Southern California Edison
ELM Project A.18-05-007

DATA REQUEST SET A1805007-ED-SCE-DEF-001

To: ENERGY DIVISION
Prepared by: Alex Ramirez
Title: Sr. Right of Way Agent
Dated: 07/17/2018

ELM Q#1 Newberry Cap 20180724

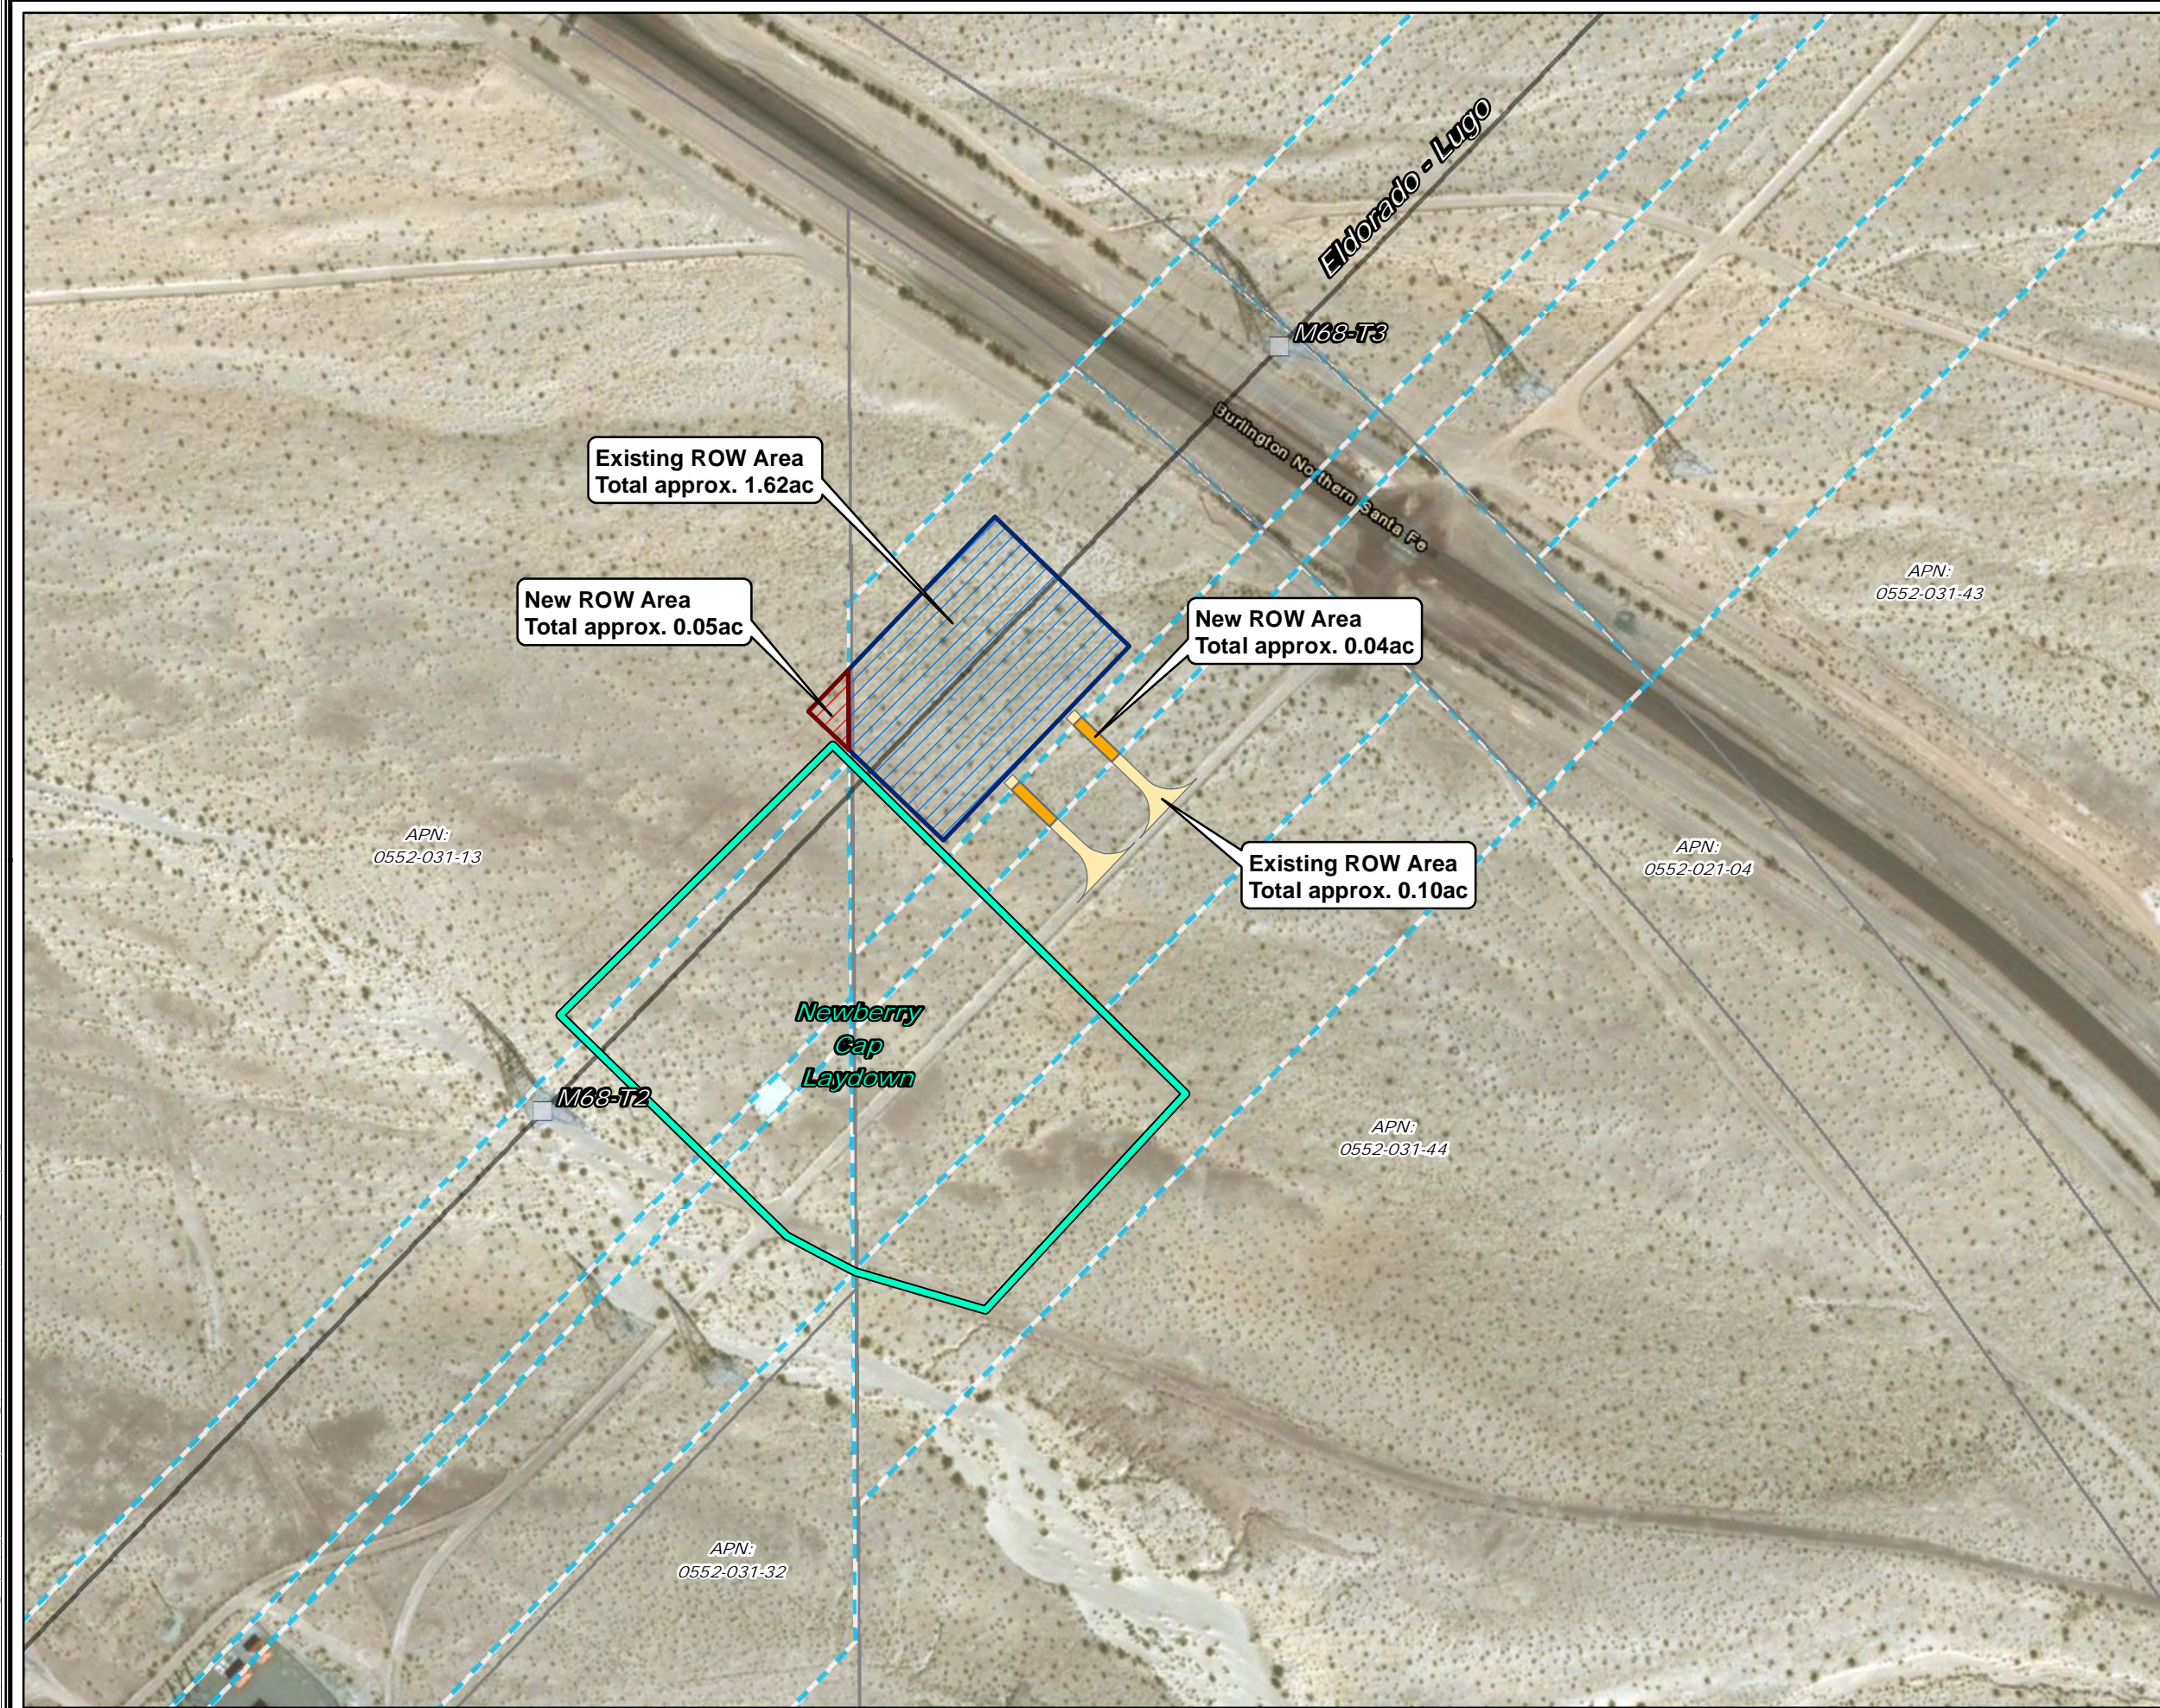
Describe if the Proposed Project is located within an existing property owned by the Applicant, traverses existing rights of way (ROW) or requires new ROW. Give the approximate area of the property or the length of the project that is in an existing ROW or which requires new ROWs.

A. Please give the approximate length of the project that is in existing ROW and the area of new ROW required, and its location(s).

The Newberry Series Capacitor is cover under the BLM ROW as follows (Due to the configuration of the existing and new ROW that is required, a precise length cannot be provided as it varies. However, please see attached map.):

Total Area - 1.67ac

Existing ROW – 1.62ac

New ROW - .05ac

Existing ROW Area
Total approx. 1.62ac

New ROW Area
Total approx. 0.05ac

New ROW Area
Total approx. 0.04ac

Existing ROW Area
Total approx. 0.10ac
